4th February 2019
Our ref: 1030_EGOVR:GM

**Re: Rix's Creek Continuation Project, Response to Recommendations –
Request for additional information from the Department of Planning and
Environment**

FIGURE 1-2

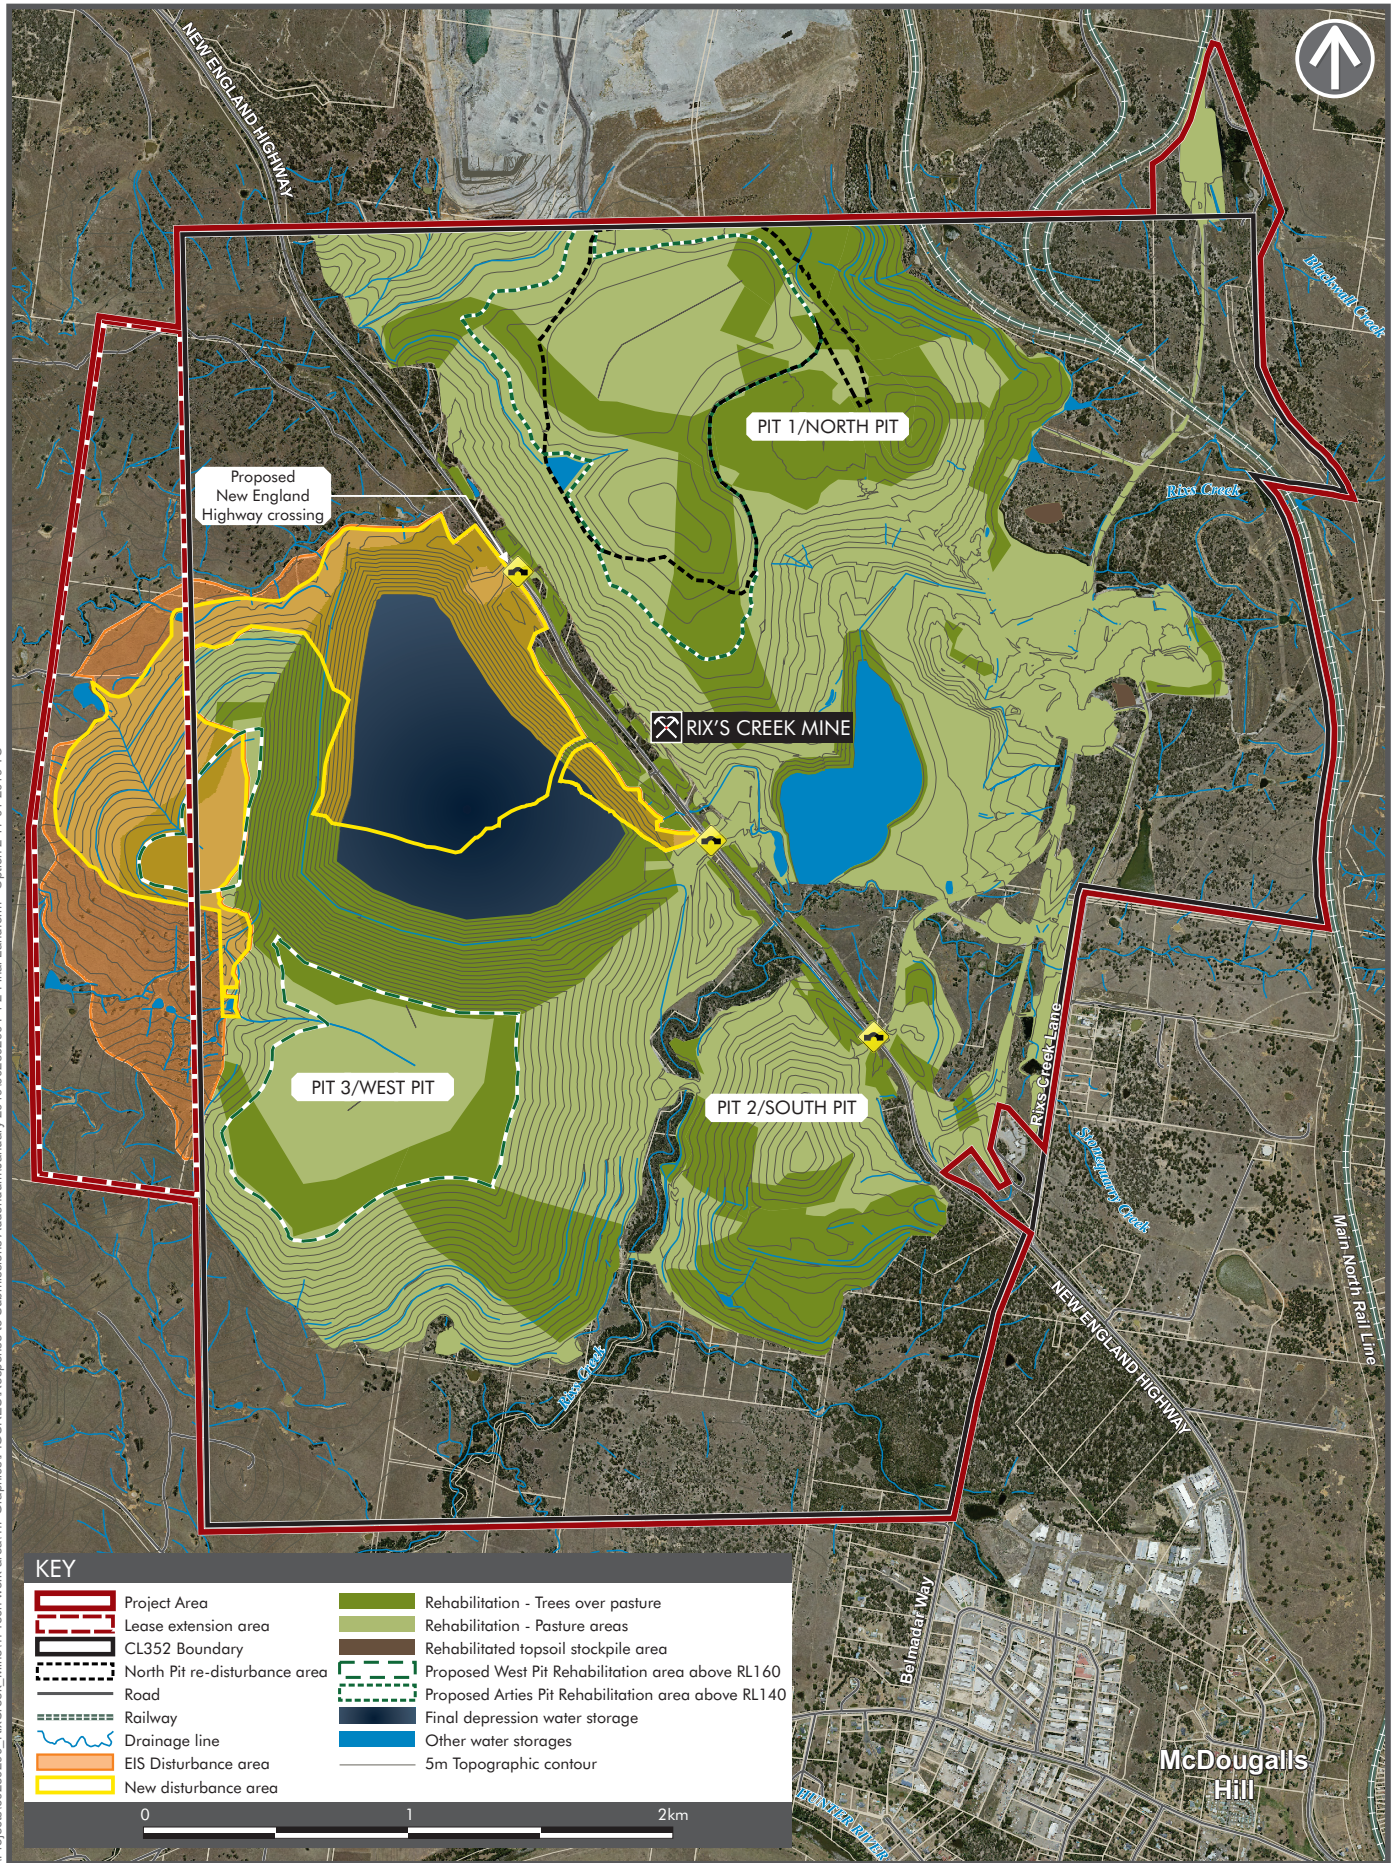
Please provide an updated development layout figure based on option 2. All key surface features should be shown and labelled, such as the disturbance boundaries, pits, OEAs, tailings storages, cut and cover tunnels, etc.

Please see a copy of the updated plans attached to this letter as Project Area – Option 2 Figure 1-1, (Attachment 3) and Final Landform – Option 2 Figure 1-2. (Attachment 4).
